## Cylinder Head Gasket Update

Multistrada 1260 Model Year 2018 – 2020

XDiavel Model Year 2016 – 2020 (all versions)

Service Repair Bulletin SRV-SRB-20-010

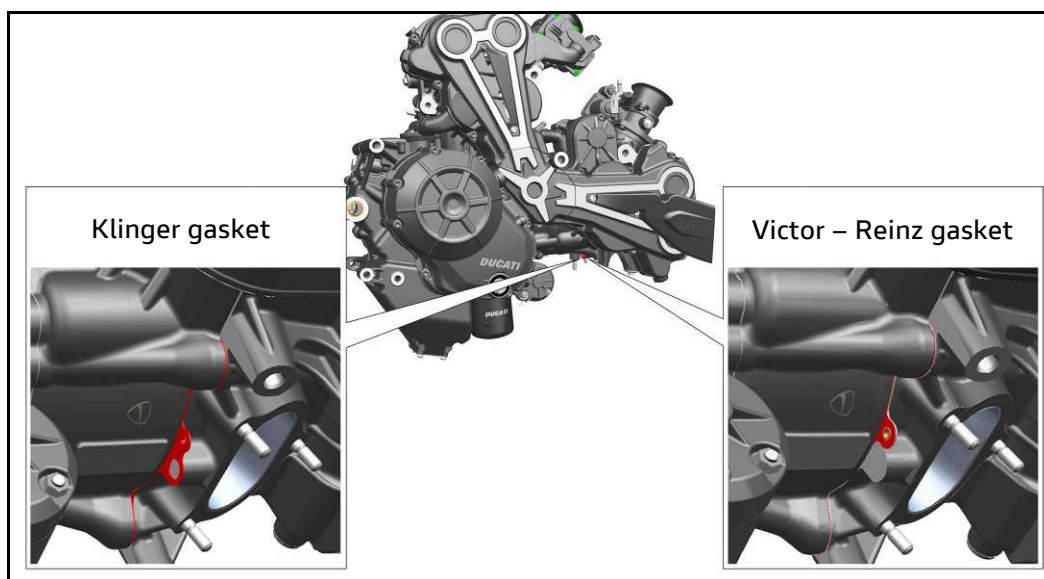
The new Victor Reinz gaskets feature additional rubber profiles on the metal gasket which, unlike Klinger gaskets, do not require additional O-rings at the oil passage points. The included table shows the gaskets with the relevant part numbers that can be installed on DVT 1262cc Testastretta engines:

Due to the different position of the water pump, the Victor Reinz gaskets installed on the Multistrada 1260 and XDiavel models are different. Also note that Victor Reinz gaskets and previous Klinger gaskets are NOT interchangeable, due to the difference in machining of cylinders.

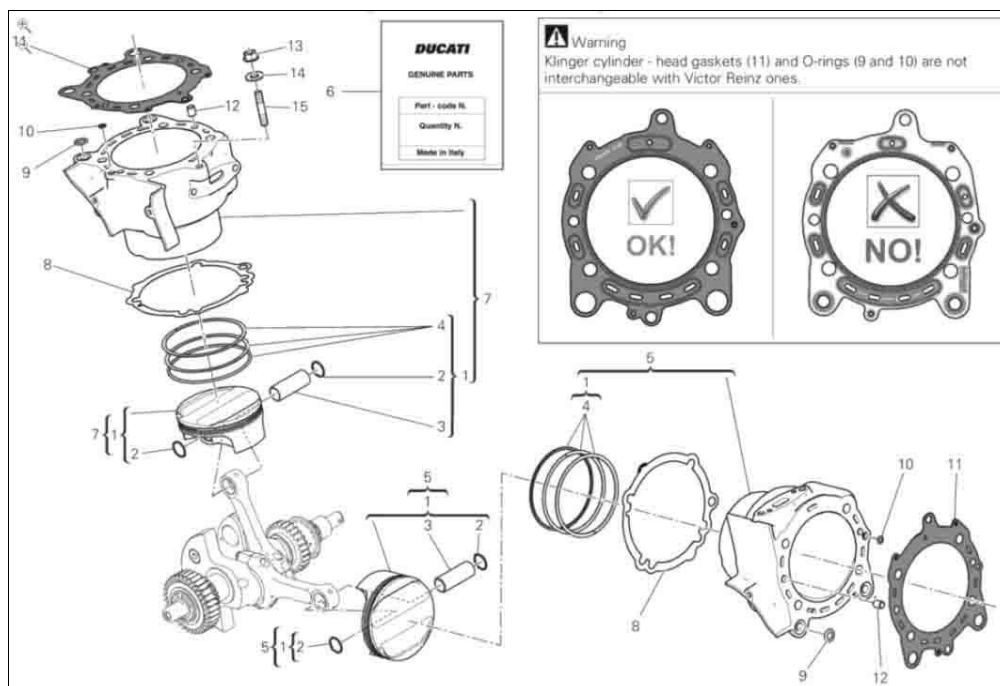
In order to recognize the type of gasket installed on Testastretta DVT 1262cc engines, please check the cylinder-cylinder head coupling in relation to the horizontal cylinder as shown in the figure below:
